Gatwick Airport Northern Runway Project

The Applicant's Response to the Rule 17 Letter (f)

Application Document Ref: 10.88

Table 1 The Applicant's Response to Rule 17 Letter (f)

Figure 1: Potential Alternative Drainage Attenuation Feature Locations overlain onto existing site feature satellite photography image

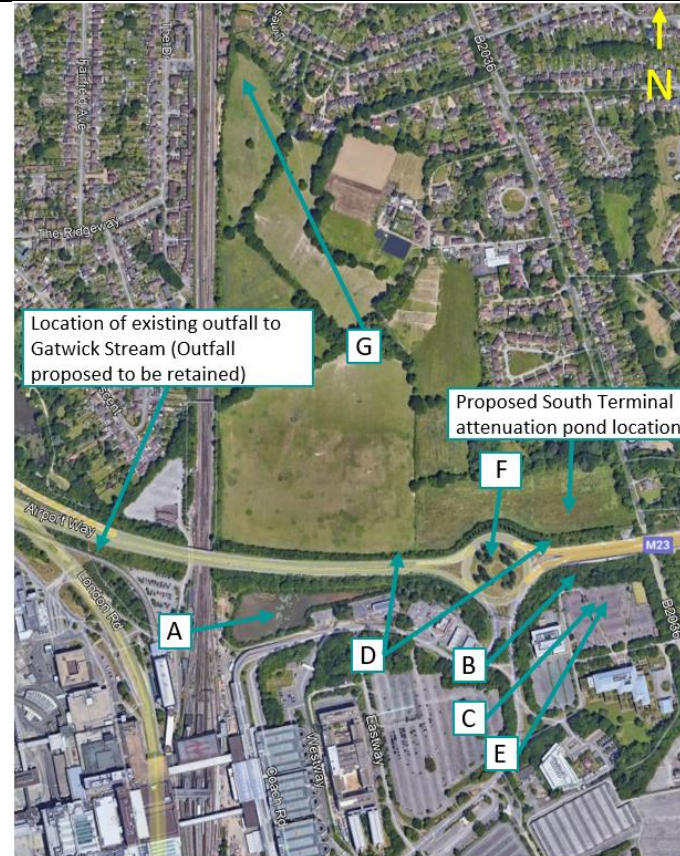
R17f	Question to:	Question:
R17f.1	Applicant	<p>Bayhorne Farm – Alternatives</p> <p>Noting the response by the Legal Partnership Authorities to ExQ2 CA.2.10 [REP7-110] and the detail contained in response to ExQ1 CA.1.11 in 'The Applicant's Response to Deadline 4 Submissions' [REP5-072], please provide additional technical justification for the discounting of all alternative locations for the proposed drainage attenuation pond.</p> <p>Reference has also been made by Surrey County Council in [AS-165] to a possible alternative site at land to the south of London Road, which is currently a car park. Please advise whether this site has been considered as an alternative in respect of drainage. If this is not considered to be a suitable site, please provide a technical justification.</p> <p>Noting that the proposed Horley Strategic Business Park is an allocated site, were alternative locations considered in respect of South Terminal roundabout contractor compound? Please list these and provide a technical justification for why they were discounted. If no alternative sites were considered, please explain why.</p> <hr/> <p>Discounting of all alternative locations for the proposed drainage attenuation pond</p> <p>The proposed location of the pond has been determined following extensive engagement with National Highways and the SCC (as the lead local flood authority (LLFA)); the technical expertise of these organisations and the specific expertise of the Applicant have identified this location as the optimum solution for the reasons set out in this response. Information on designs has been supplied to National Highways and the LLFA and feedback has been provided through an iterative approach to inform the designs and, for the purposes of this response, the location of the attenuation pond.</p>

The key reasons why the alternative locations proposed by SCC were discounted in addition to the detail provided in **The Applicant’s Response to Deadline 4 Submissions’** [\[REP5-072\]](#), are set out below. The Applicant responded to SCC’s proposed locations in **The Applicant’s Response to**

<p>Deadline 4 Submissions’ [REP5-072]. Technical justification for why the alternative locations proposed by SCC were discounted is provided below:</p> <p>Location A - Existing Pond Southwest of South Terminal Roundabout</p> <p>This is an existing attenuation pond in this location which is referred to as "Pond F". This provides attenuation to the airport itself. It would not be practical to enlarge or amend this pond to also service the highway assets owned by National Highways and, further National Highways requires that its assets have dedicated attenuation features and will not allow for features to be combined with assets owned/ operated by a third party.</p> <p>In accordance with technical engagement with National Highways and their development and operational policies, separate drainage networks are required for each highway authority. This enables each entity to have full control of, and responsibility for, their assets including in relation to design, maintenance, flood risk and water quality requirements and managing pollution risk. This ensures that each highway authority is responsible for compliance with their own policies and that they can fulfil their statutory functions. Accordingly use of Gatwick’s Pond F to act as an attenuation pond for National Highways assets is not acceptable from a practical or an operational perspective.</p> <p>Location B - Southeast of South Terminal Roundabout in the existing wooded area</p> <p>There is insufficient space to accommodate the required attenuation pond at this location.</p> <p>The existing tree planting in this area is proposed to be removed to accommodate the proposed Gatwick Spur Eastbound Diverge slip road (and associated infrastructure such as retaining wall provision) and the proposed pedestrian link between Balcombe Road and South Terminals forecourt network (Work No. 35). The pond would be required to attenuate 2900 cubic meters of storage which equates to a size of approximately 85m long by 40m wide and a depth of 2.0m, there is therefore</p>

<p>insufficient space between the new slip road, pedestrian link and car park to accommodate the pond between these assets and the car park.</p> <p>Location C - Southeast of South Terminal Roundabout in the existing car park</p> <p>The provision of an attenuation pond on the southern side of M23 Spur would result in the pond being closer to the flight paths at the airport introducing an unacceptable safeguarding risk.</p> <p>A pond of the nature required will attract birds and the proximity to the runway and other vegetation means that the risk of plane bird strikes would be increased relative to ponds positioned on the northern side of M23 Spur. The M23 Spur also acts as a deterrent for birds flying south towards the runway which serves to reduce the risk of bird strikes; this location does not have an equivalent deterrent.</p> <p>Further, this location is currently an existing car park and is not a GAL asset. The car park is proposed to be retained following completion of the NRP surface access works. A new pond at this location would have required permanent acquisition of a large portion of this existing car park and would have a substantial operational impact on the associated landowner/ business and the car parking operations around the airport.</p> <p>Location D - Two longer narrower ponds north of M23 Spur (within the existing highway boundary where possible)</p> <p>There is not sufficient space for ponds within the existing highway boundary even if these were to be narrow ponds.</p> <p>The proposed highway footprint (including the earthworks associated with the South Terminal Roundabout Slip Roads) means that it is not possible to develop a pond solution within the existing</p>

<p>highway boundary because there is insufficient space for the size of pond that is required. Any ponds located to the north of the highway will therefore need to be outside the existing highway boundary.</p> <p>Were the ponds to be included in the proposed highway boundary, the overall footprint would be required to be larger and that would lead to a greater impact to the land north of M23 Spur / Airport Way. Narrow ponds would need to be significantly larger in footprint than the ponds currently proposed because they cannot store as much water; the full depth area is in the middle of any given pond but additional storage is obtained through shallow side slopes which allow for a greater increase in storage volume than steep side slopes. Narrow ponds would require steeper sides.</p> <p>A further reason why long narrow ponds are not preferred relates to safety/safeguarding issues associated with the risk of plane bird strikes. Two long narrow ponds would have a larger wet surface area, increasing the risk of birds being attracted to the area and as a result increasing the risk of bird strike.</p> <p>Location E - Below ground storage at existing car parks</p> <p>A below ground storage solution (e.g. tanks) does not align with LLFA or National Highway policy both in terms of attenuation solution types and maintenance access preferences.</p> <p>A previous proposal for an underground storage tank at the existing Car Park Y to provide attenuation for a portion of the West Sussex County Council's surface access highways works associated with Work No. 36 (North Terminal Roundabout Improvements) was removed as a result of WSCC LLFA requests during earlier stages of the design (as described further below in reference to Location H). These solutions also do not comply with National Highways' operational policies because of the challenges of accessing for maintenance.</p>

<p>In addition, as noted for option C, this existing car park is not a GAL asset and the permanent acquisition of a large portion of this existing car park would have a substantial operational impact on the associated landowner/business and the parking operations surrounding the airport.</p> <p>Location F - Below ground storage in the South Terminal Roundabout Central island</p> <p>Two bridge piers are proposed in the roundabout central island. These piers and the associated foundations preclude the provision of a storage tank at this location from a practical perspective.</p> <p>Location G - Northwest Corner of Bayhorne Farm</p> <p>This location is not suitable to facilitate a functioning attenuation pond.</p> <p>The reasons it is not feasible are:</p> <ul style="list-style-type: none"> ▪ Location G is within Flood Zone 2 associated with the Haroldsla Stream and is also in an area of surface water flooding in relation to rainfall events, these events would require additional storage capacity within the attenuation pond to mitigate the surface water flooding in this location, therefore increasing the size of the pond. ▪ Conveying highway runoff to Location G would pose numerous technical and practical challenges in particular because of its distance from the proposed highway. Key challenges would include: (i) Gradient issues associated with existing ground levels and the distance between the highway assets and the pond location; (ii) Increased pond depth requirements and (iii) a likely requirement for pumping station provision. These issues would result in substantial technical approval risks which are considered unlikely to be accepted by relevant technical approval authorities. ▪ There is a risk that the outfall of a pond in this location would need to be changed from Gatwick Stream to Haroldsla Stream. This is unlikely to be considered favourable by the
